**CLASS 2 MODIFICATION
TO THE
TOCDF RCRA PERMIT**

REQUEST NUMBER: TOCDF-SDS-02-0899

**REQUEST TITLE: SPENT DECON TANK REMOTE SAMPLING
SYSTEM**

**TO: UTAH DIVISION OF SOLID AND HAZARDOUS WASTE
1460 WEST 288 NORTH
P. O. BOX 144880
SALT LAKE CITY, UTAH 84114-4880**

Sheet reference number:
EG-01-D-3501

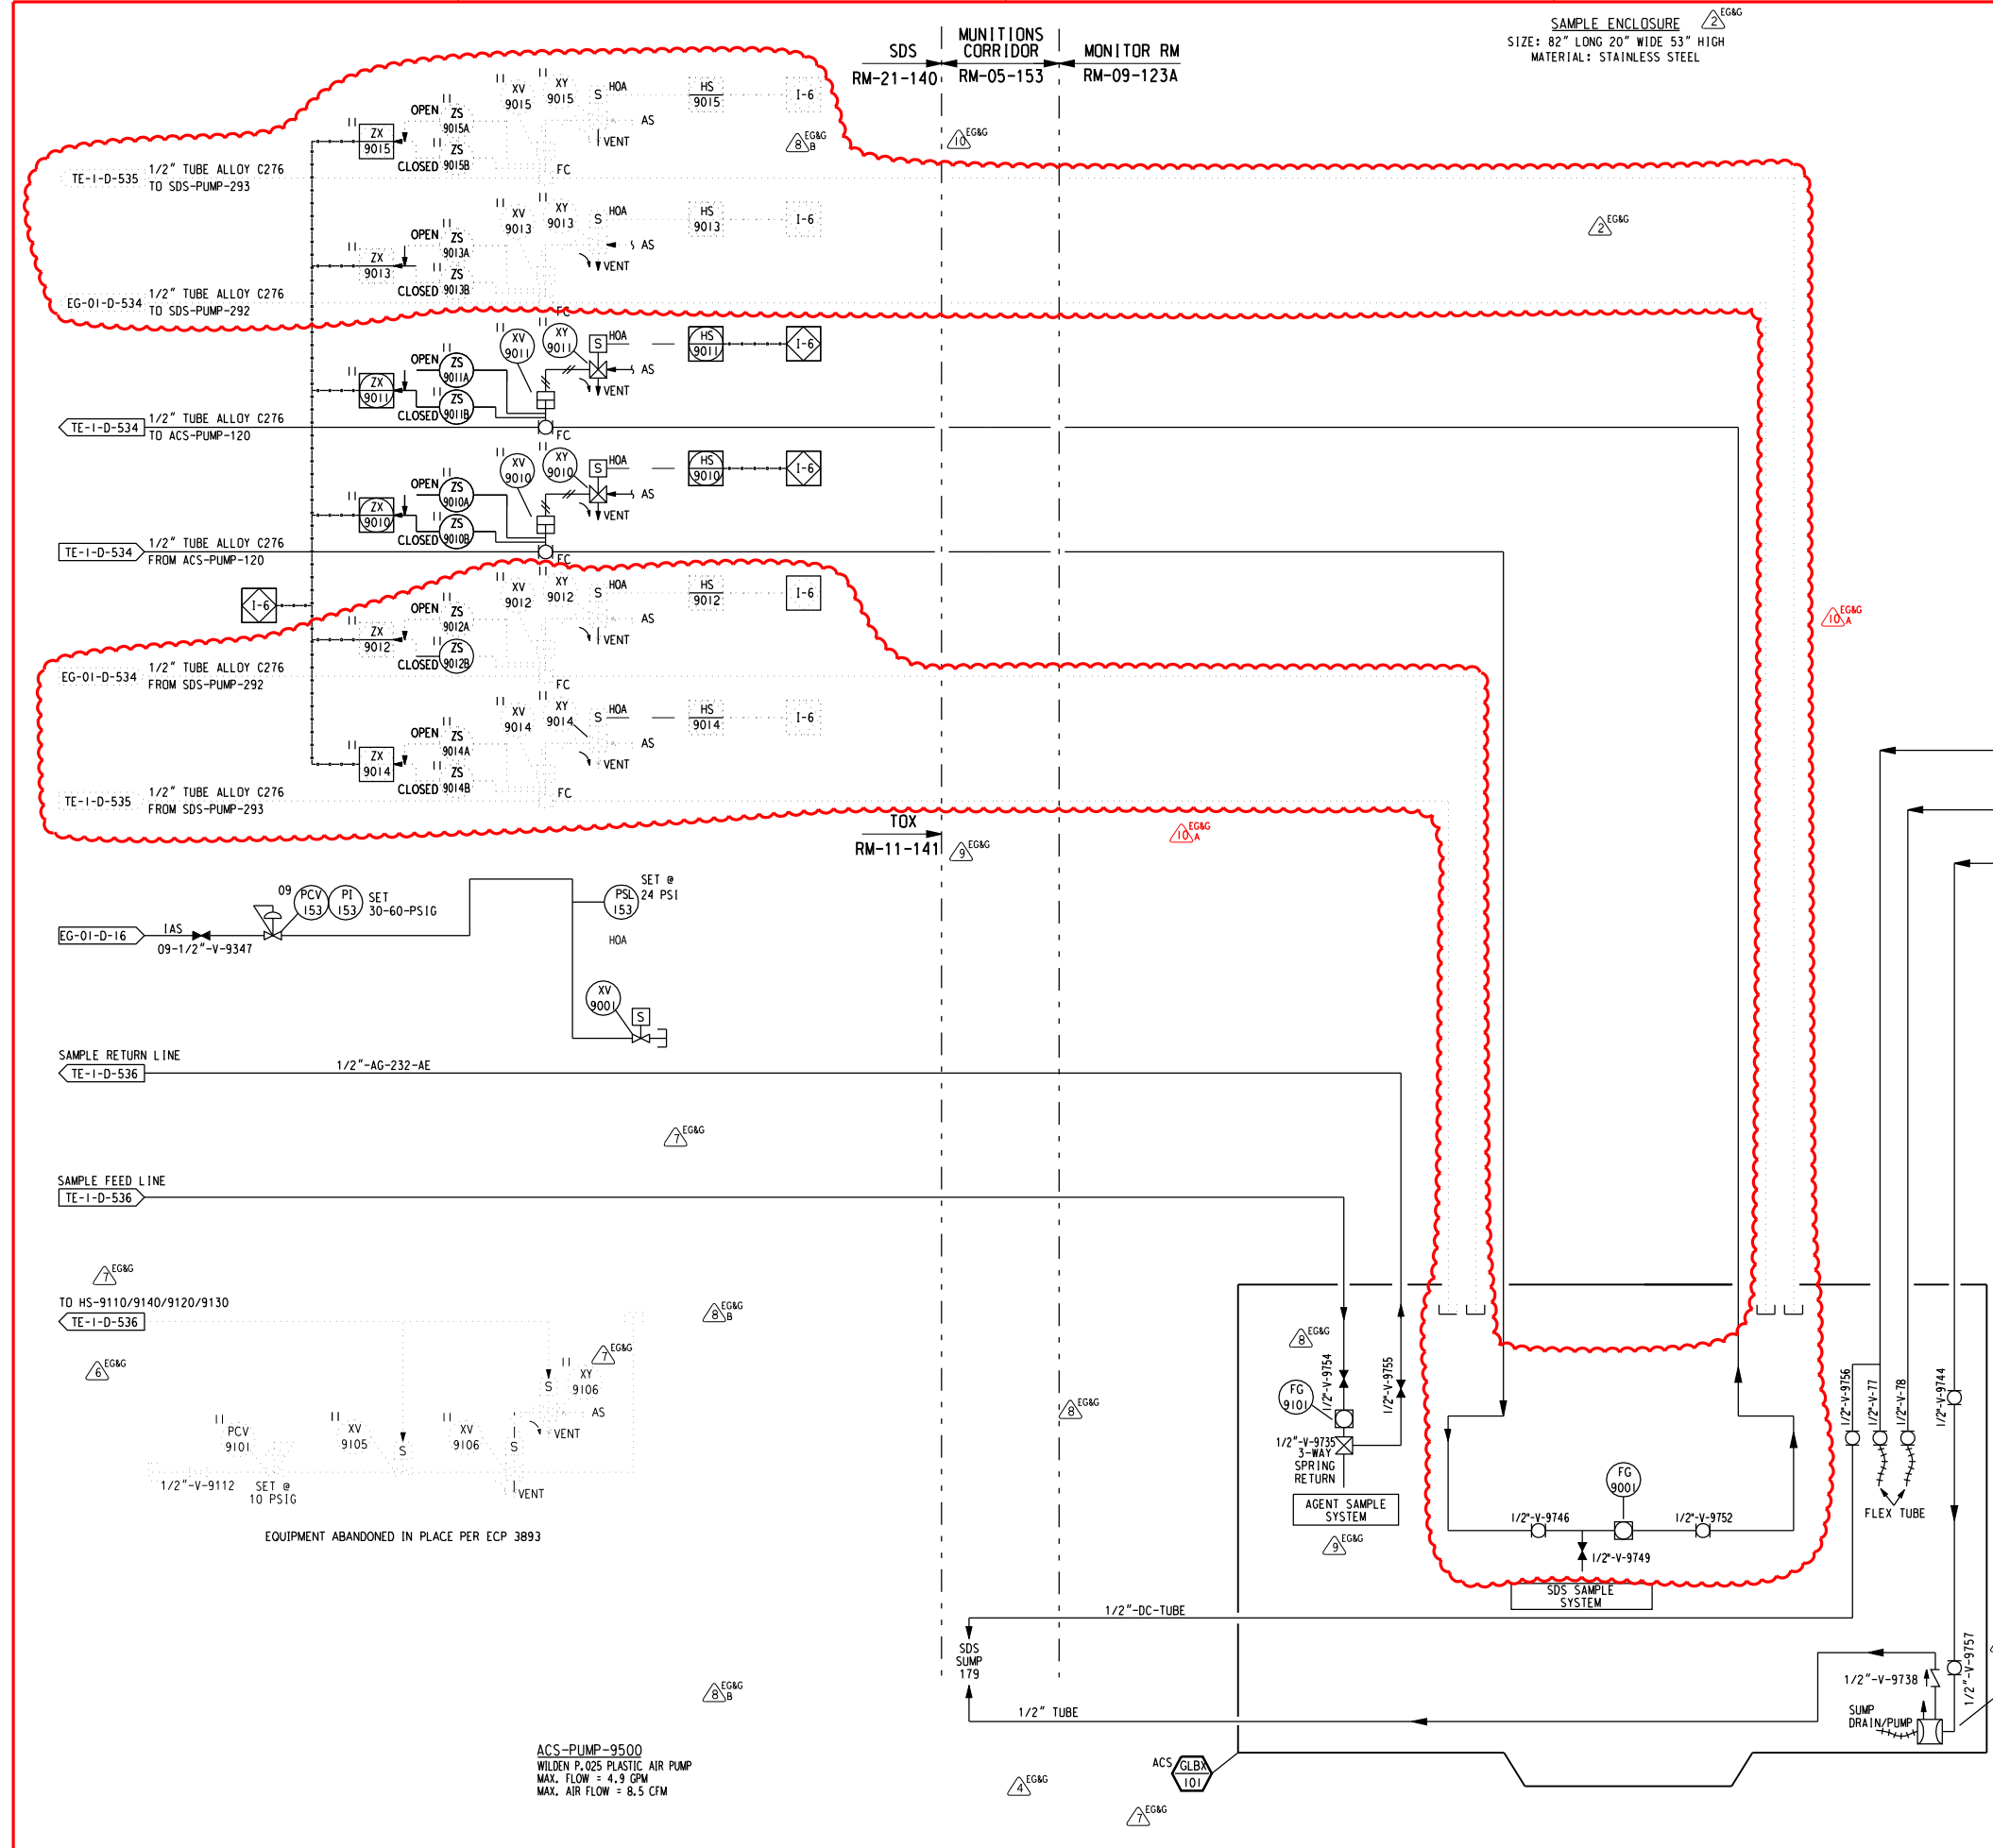
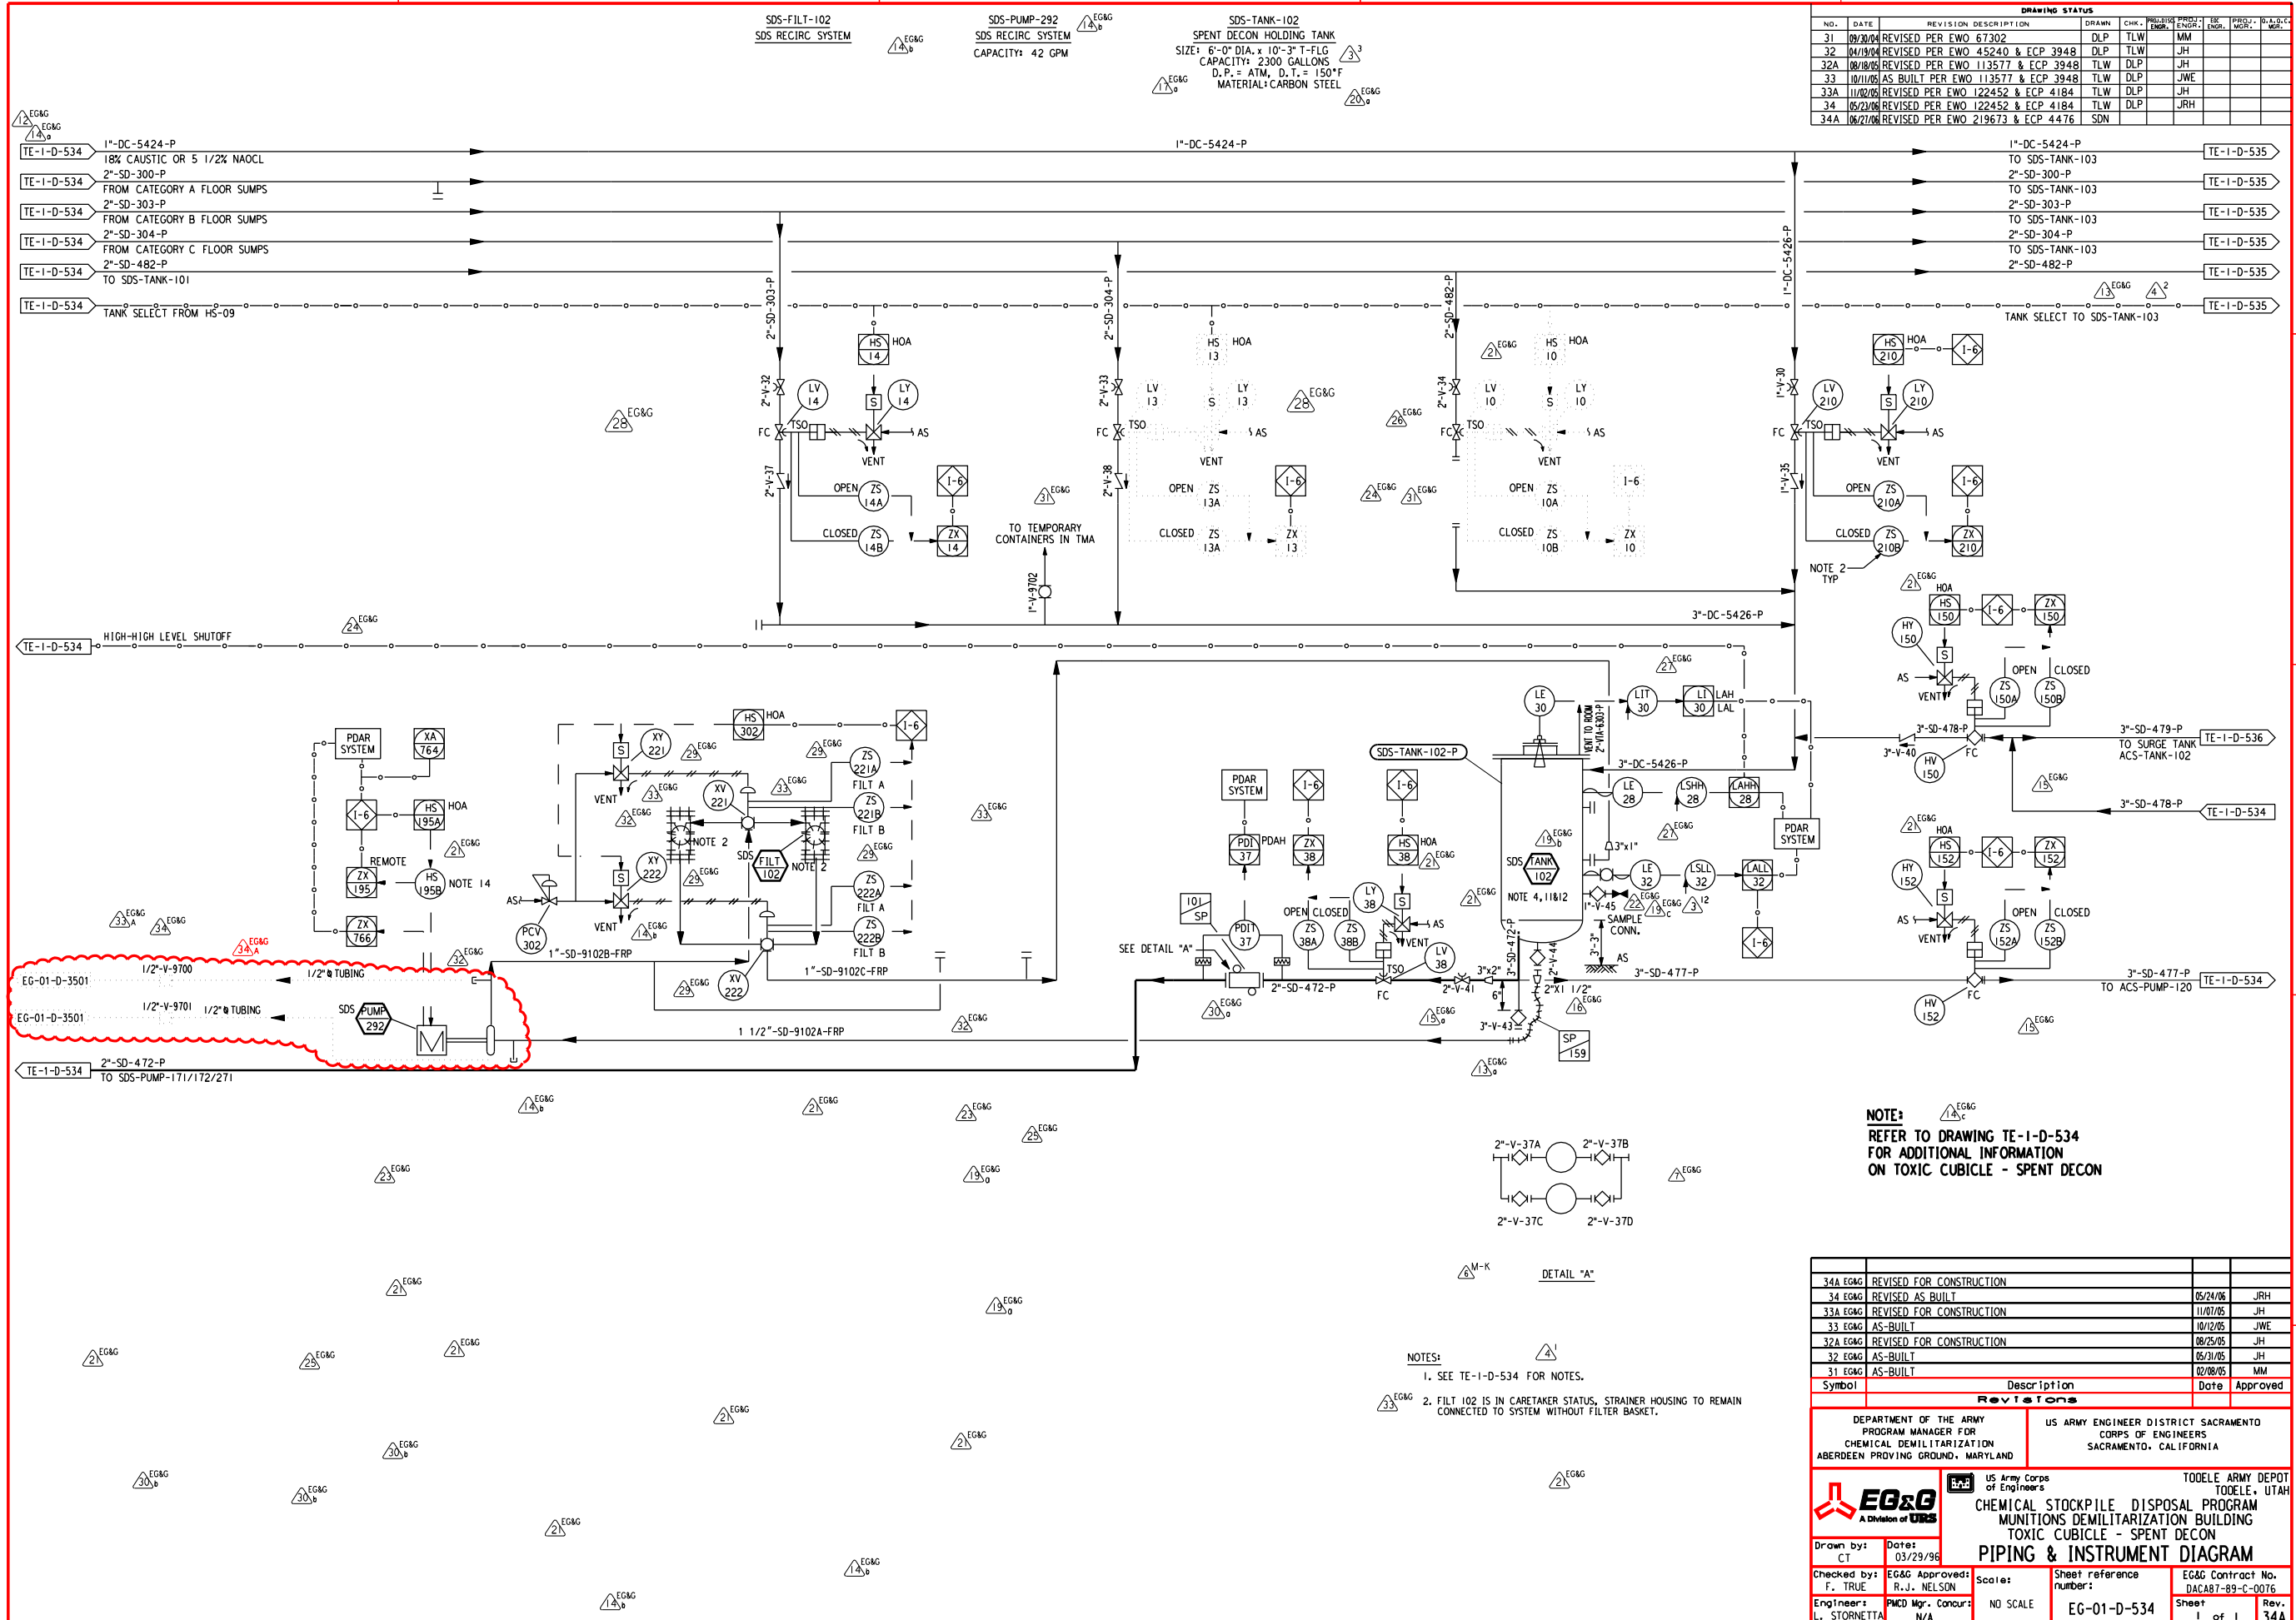
At the ASR glovebox, instead of having three supply/return sample line pairs (one pair for each SDS tank), the single supply/return sample line pair that previously served SDS tank 101 will be the only sample line pair to remain in use, although that sample line pair will be able to serve all three SDS tanks.

| 4. EG-01-D-3501 | TOX - Remote Agent Sampling System |
